ALERT SERVICE LETTER

Subject: Electric Swivel Operation

Electric Swivel P/N 232-457-00 with Serial Number 119 and previous. The swivel may have been purchased under one of the following kit numbers:

Figure 1: Swivel chamfers

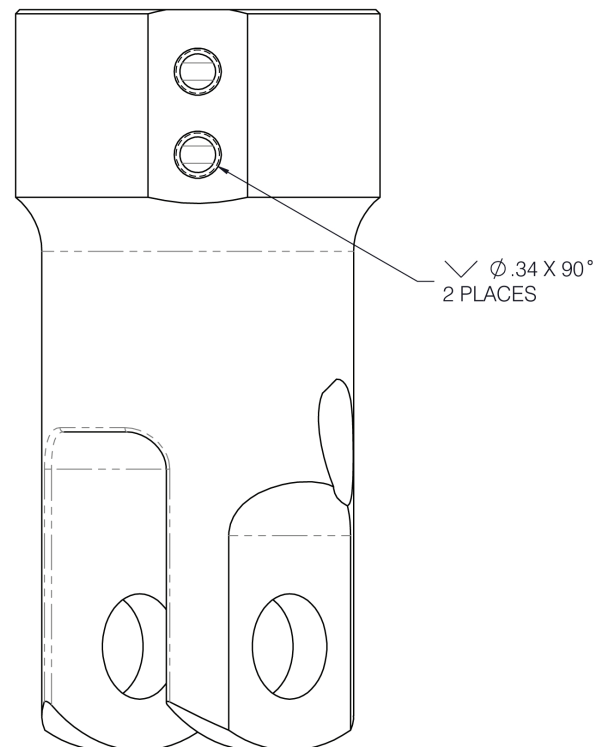
Onboard Systems has received reports that some electric swivels fail to turn freely under load. It has been determined that two issues may lead to binding of the swivel:

1. **Missing chamfer on swivel body P/N 291-538-00.** A missing chamfer on some build lots of 291-538-00 can offset the sealing bolt and cause ball bearings to not rotate freely in their races.
2. **Lack of break-in procedure.** A break-in procedure is necessary for optimal performance of the swivel. Without this procedure, the swivel may not be able to turn freely under load, depending on how it is initially used.

- ◆ Disassemble the swivel per instructions in Owner's manual 120-205-00, Section 3.
- ◆ Inspect P/N 291-538-00 for required chamfers. If chambers are not present, create chamfers per the illustration in Figure 1.
- ◆ Reassemble the swivel per instructions in 120-205-00, Section 3 and internal planning guidelines for 232-547-00.
- ◆ Perform the break-in procedure by completing Acceptance Test Procedure 180-212-00, revision 2 or later. The torque required to rotate the swivel must be less than 3.5 feet-LB at 3,000 LB and 5 feet-LB at 6,000 LB.
